Addendum No. 1

RE: Contract # C205036

Robeson County (U-5797)

SR-1997 (FAYETTEVILLE RD) FROM FARRINGDOM ST TO EAST 22ND ST

-L- STA. 23+50.00 TO 25+12.05(BEGIN ROUNDABOUT)

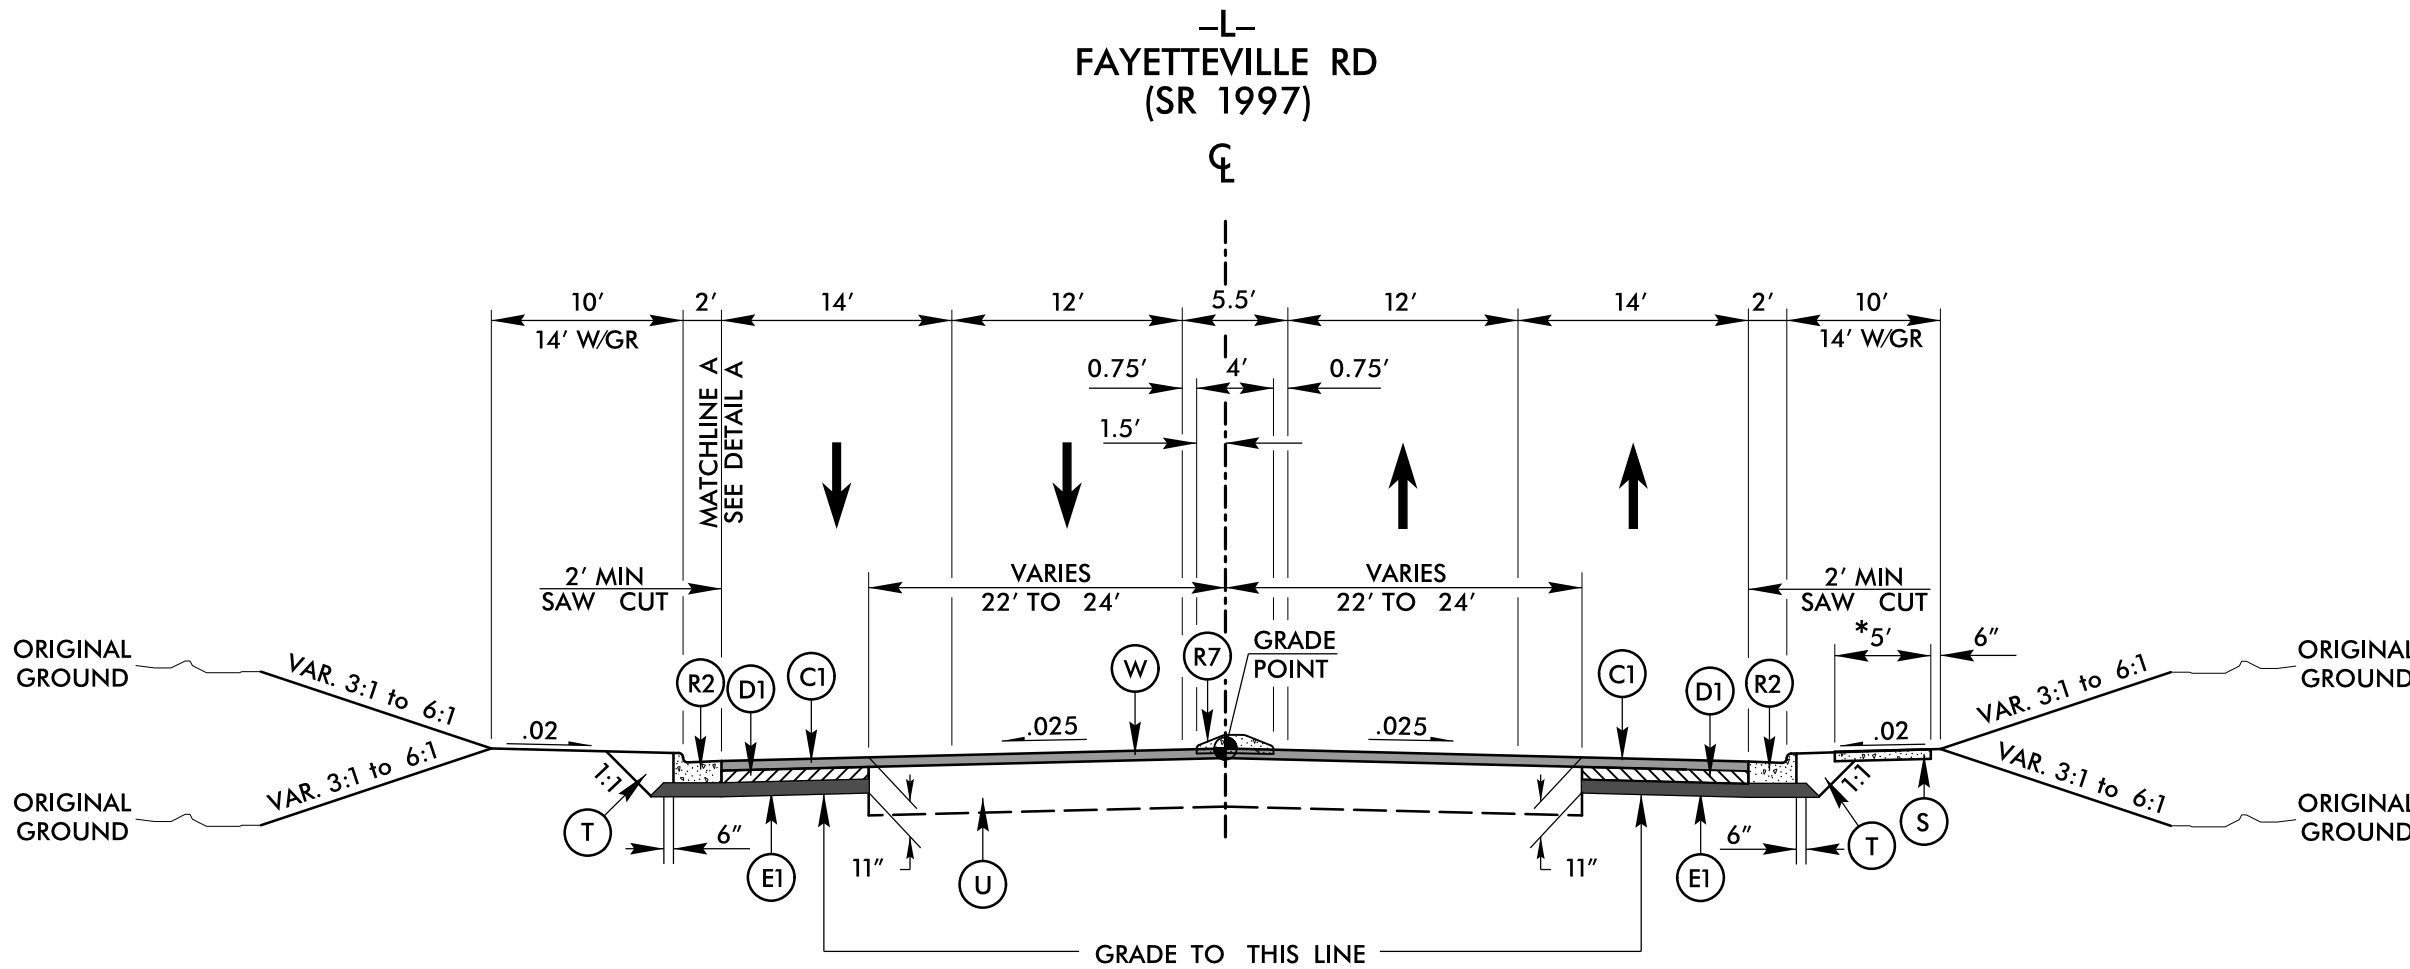
Sheet No.	Revision
Title Sheet	Revised Letting Date and -Y2- End Construction Label
1A	added sheet 2A-5 to index
2A-1	Typical Section 1 renamed to 1A. Typical Section 1B created to show full depth
2A-2	Typical Section 5 renamed to 5A. Typical Section 1B created to show full depth
2A-3	Typical Section 8 updated to show saw cut varies from 2' to 10' Typical 10 renamed to 10A. Typical Section 10B created to show full depth Detail G updated to match plan view Detail H deleted Typical Section 12 moved to sheet 2A-4
2A-4	Typical Section 12 renamed to 12A. Typical Section 12B created to show full depth
(New) 2A-5	The previous sheet 2A-4 moved to sheet 2A-5 -L- and -Y2- stations added to Typical section 13 and removed from typical section 14 Typical Section 14 updated with -Y- stations and added concrete island

PROJECT REFERENCE NO.	SHEET NO.
U-5797	2B-2
RW SHEET NO.	
ROADWAY DESIGN ENGINEER	 STV Engineers, Inc. 2121 RDU Center Dr. Suite 210 Morrisville, NC 27560 NC License Number F-0991
DOCUMENT NOT CONSIDERED FINAL UNLESS ALL SIGNATURES COMPLETED

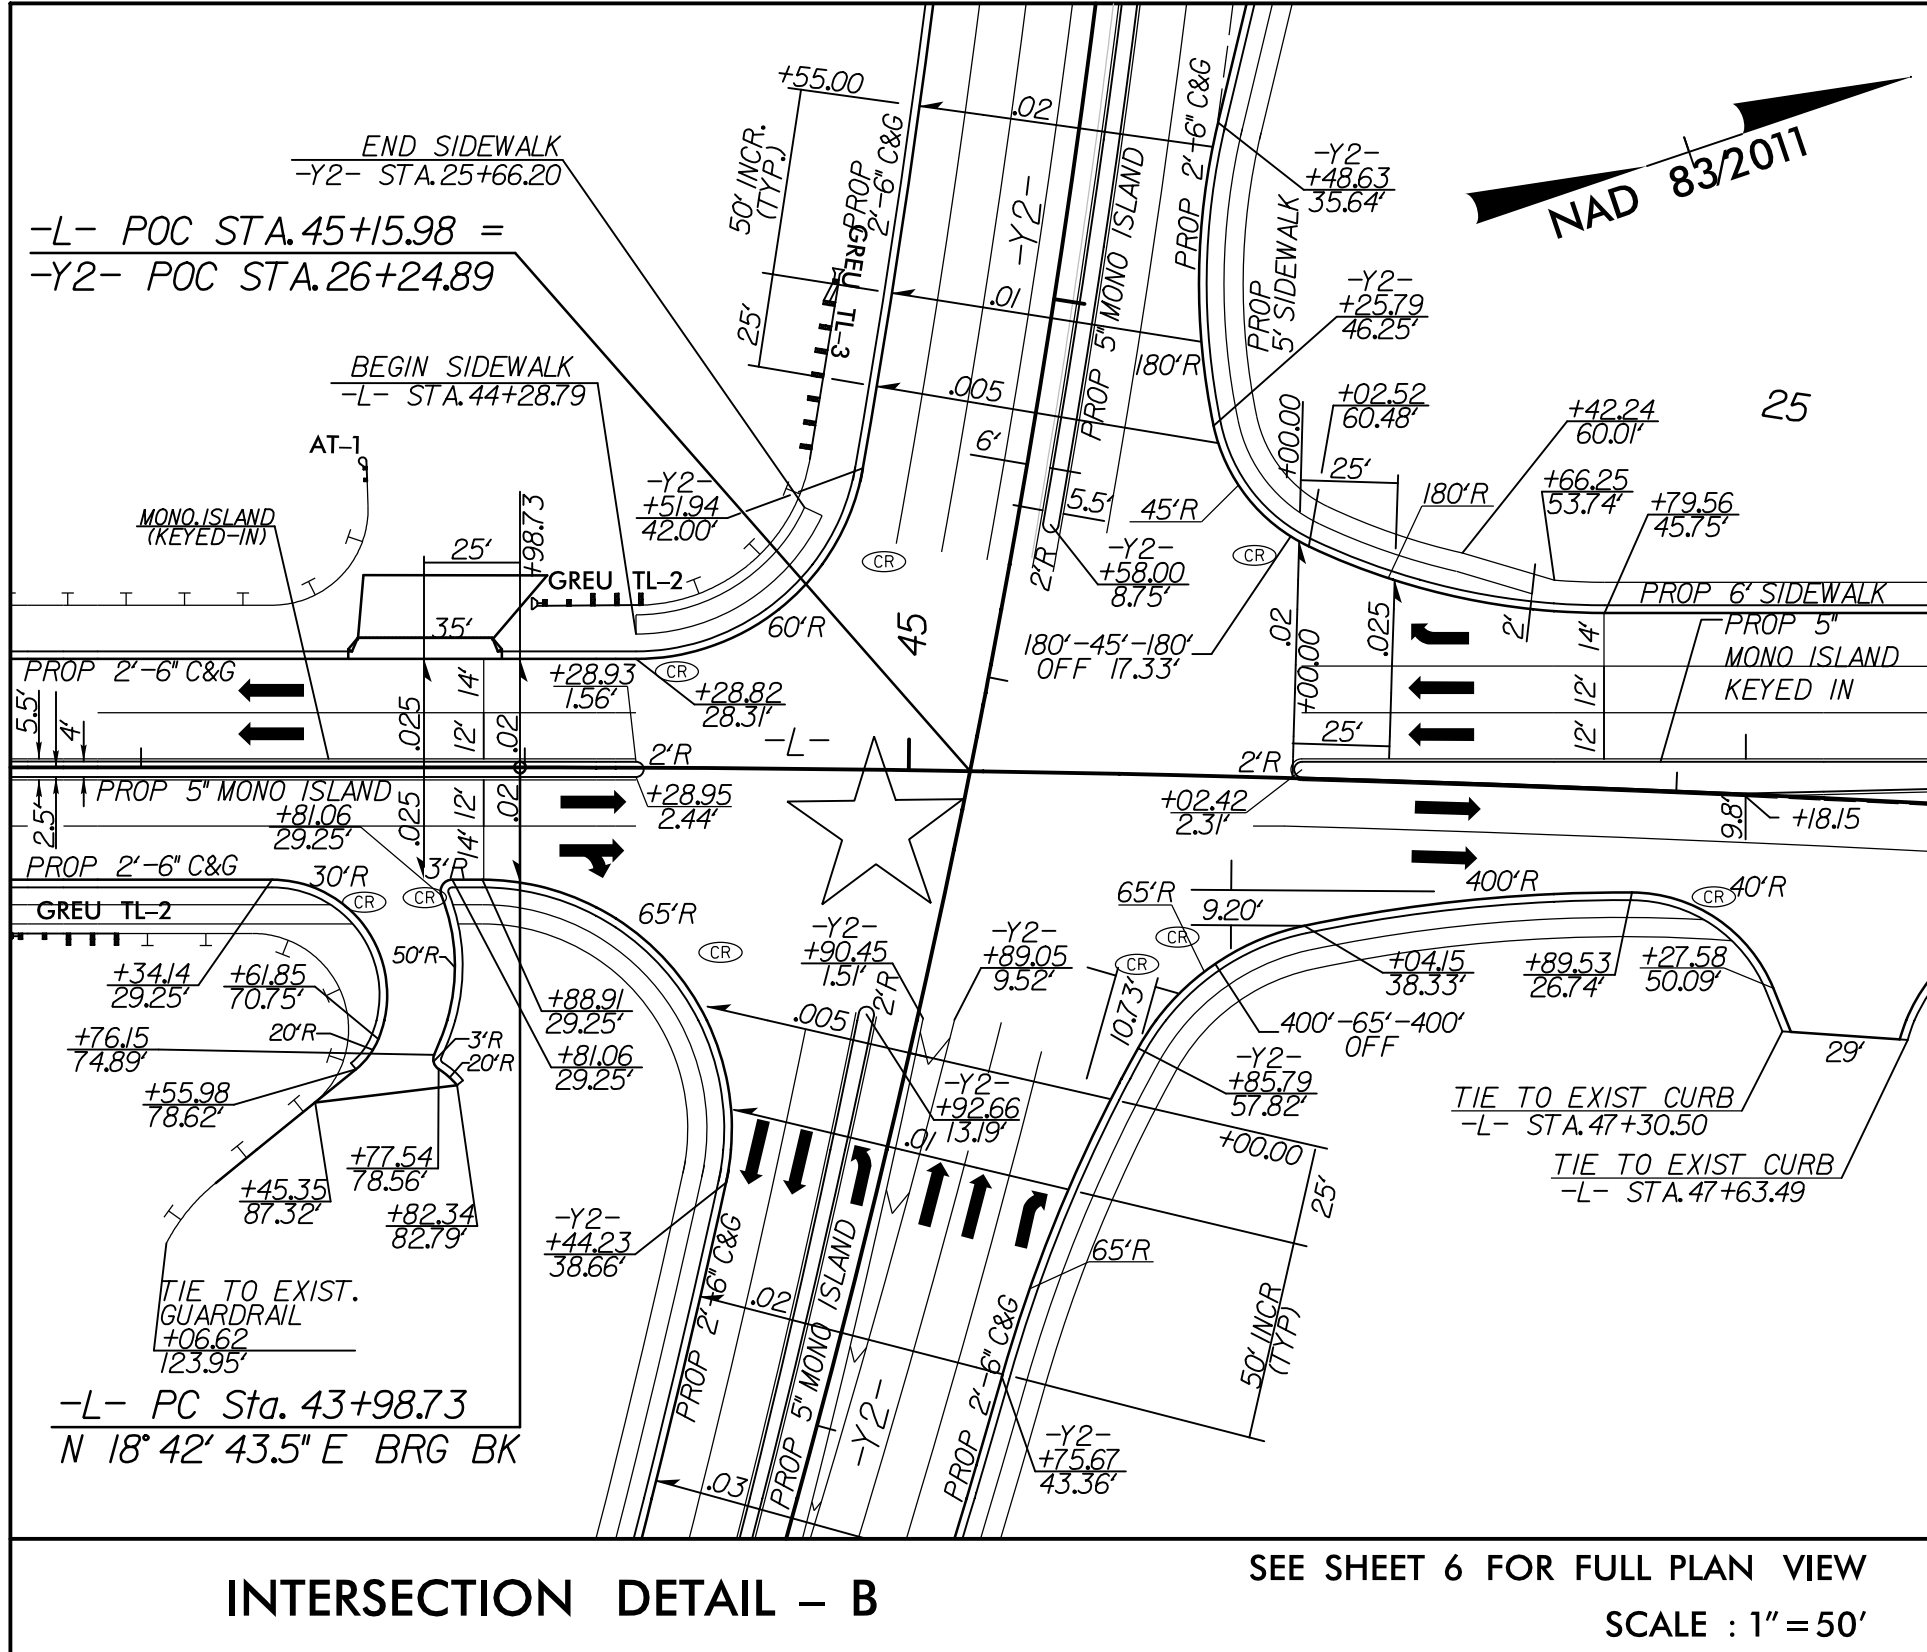
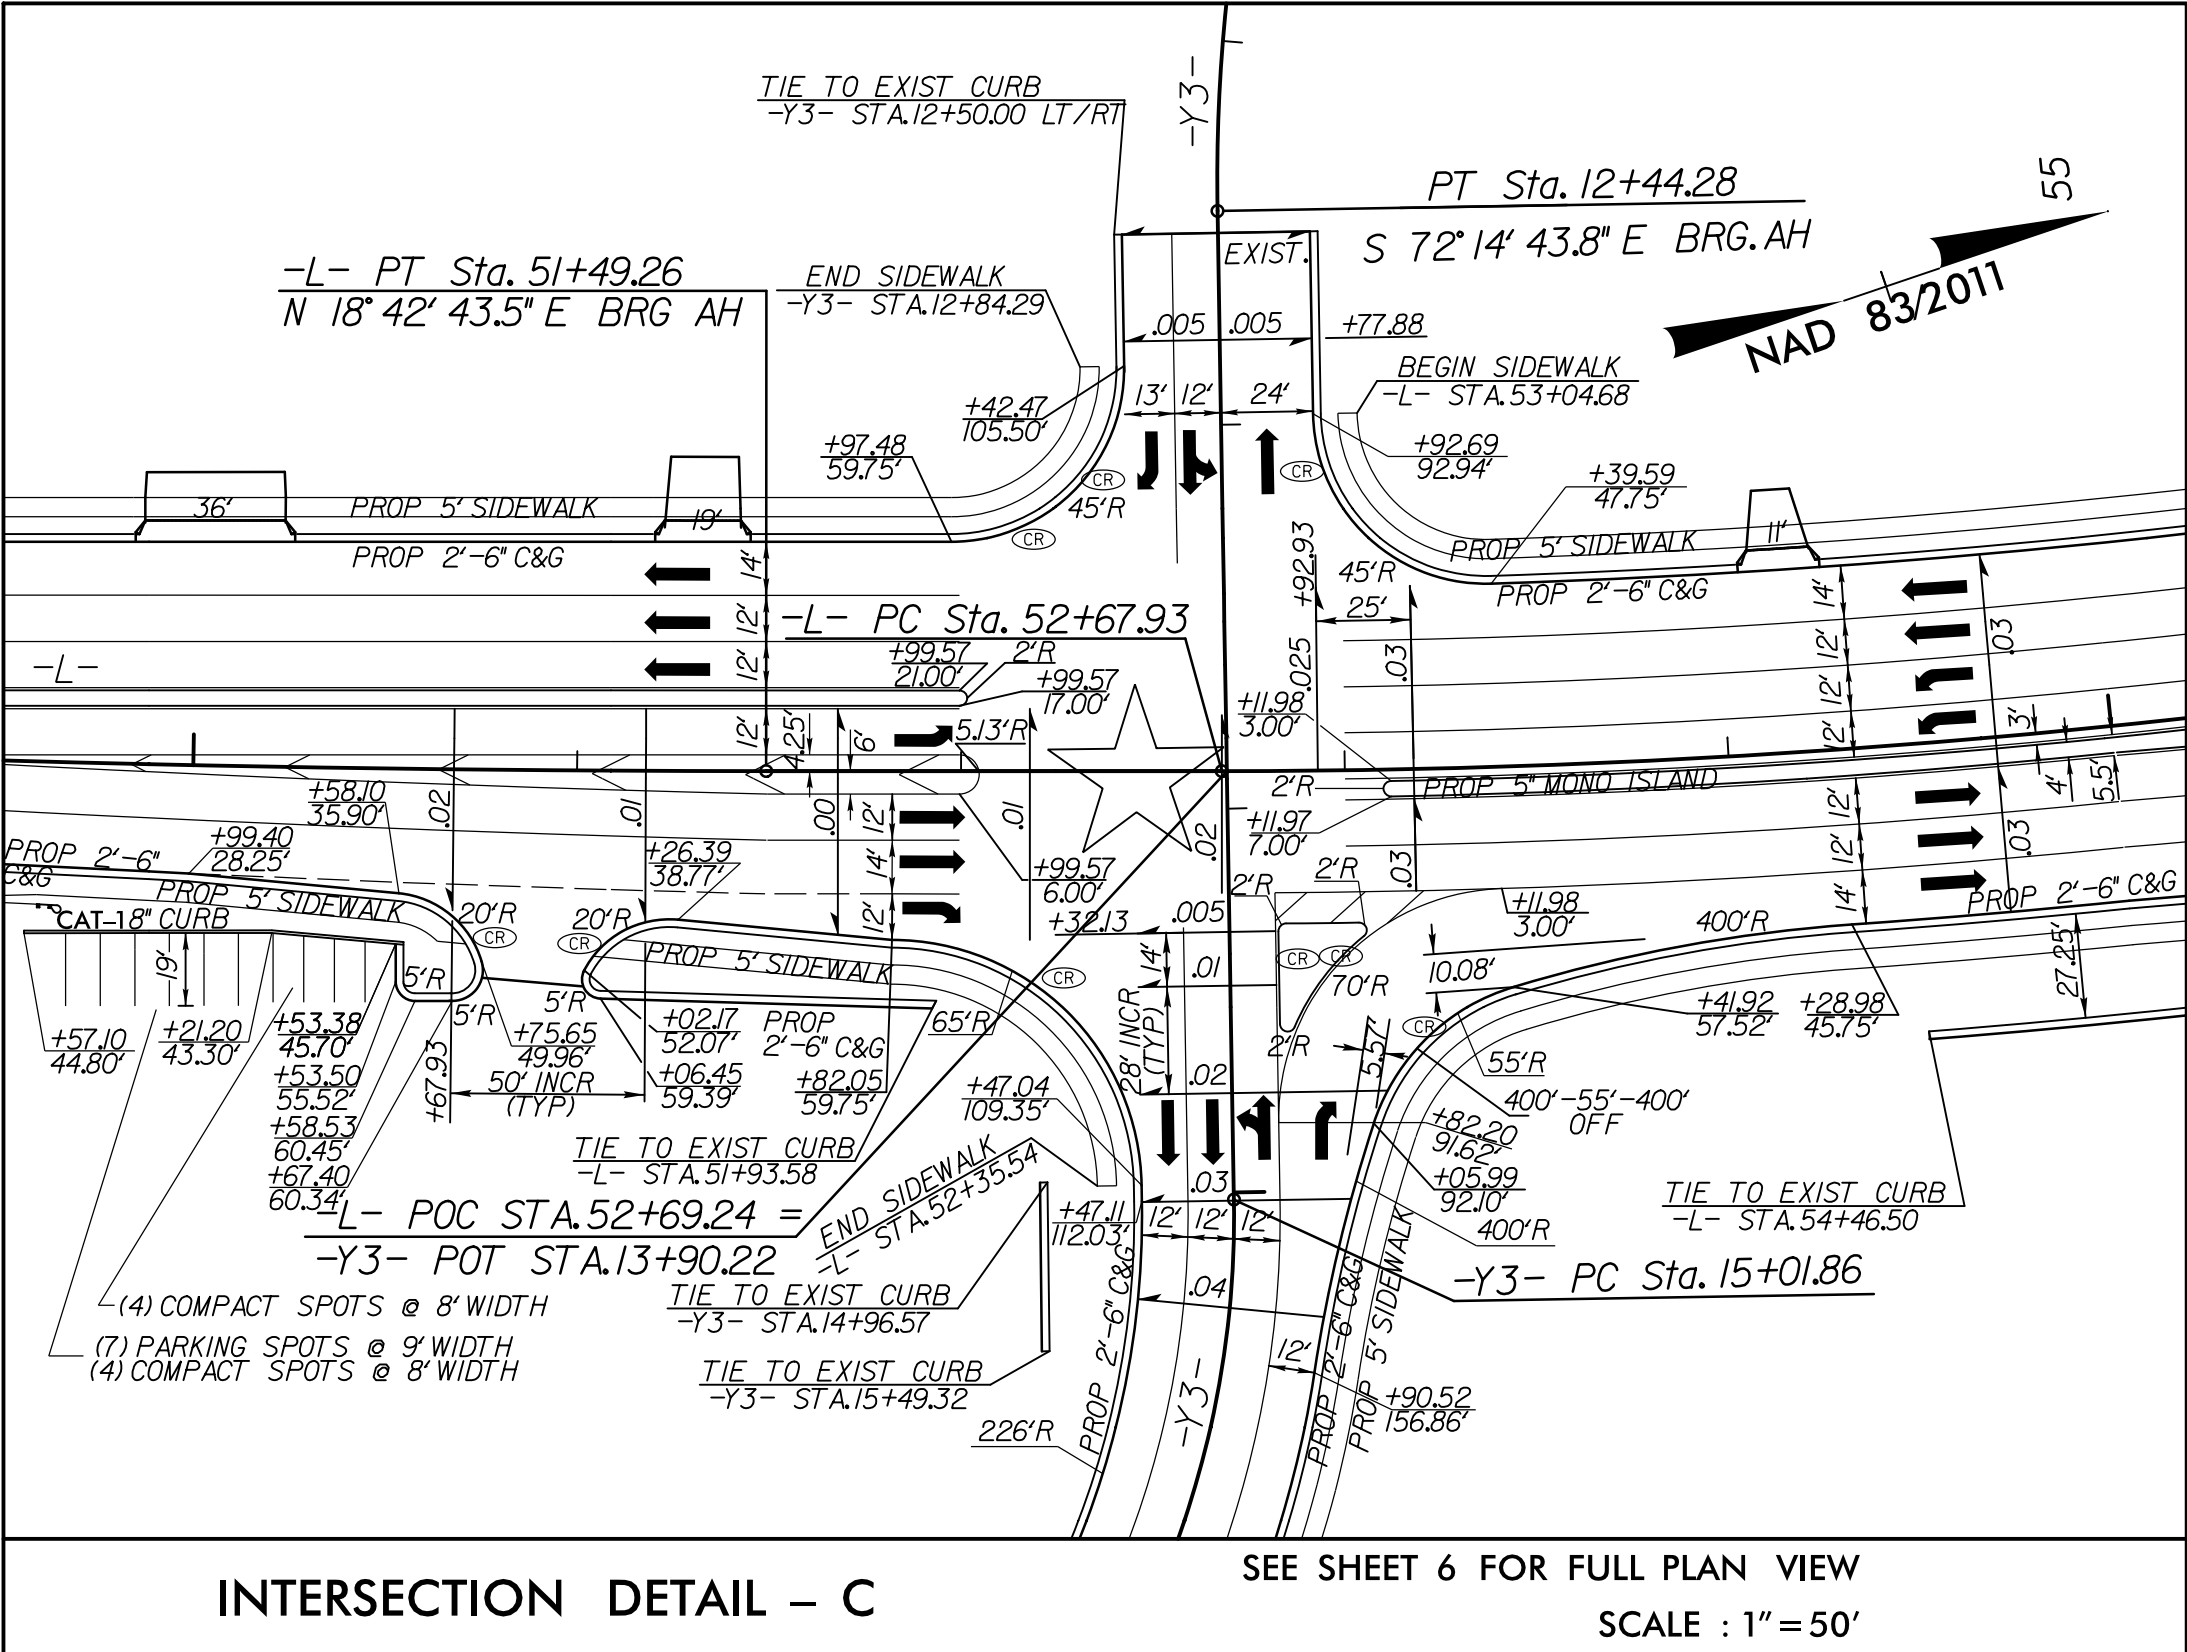
2B-2	Updated Intersection Detail D to match updated design
2B-3	Deleted the Roberts RR crossing from this sheet. Island shortened to be outside of Railroad ROW
2B-6	Deleted the Roberts RR crossing from this sheet. Island shortened to be outside of Railroad ROW
3B-1	Earthwork Updated for Y2 updates
3B-2	Pavement Removal Summary Updated
3D-11	• 1101 Box removed • 1101-1100 pipe removed • 1102 box removed • 1102-1101 pipe removed • 1103 box removed • 1103-1101 pipe removed • 1104 box removed • 1104-1101 pipe removed • 1105 box removed • 1105-1104 pipe removed • 1106 box removed • 1106-1105 pipe removed 1110 through 1114 pipes and boxes moved from sheet 3D-12 to sheet 3D-11
3D-12	• 1107 box removed • 1107-1104 pipe removed • 1108 box removed • 1108-1104 pipe removed • 1109 box removed • 1109-0674 pipe removed Lines shifting up
3D-13	• Y2 36+37 Flowable fill removed • Y2 35+57 and Y2 34+71 pipe removal removed
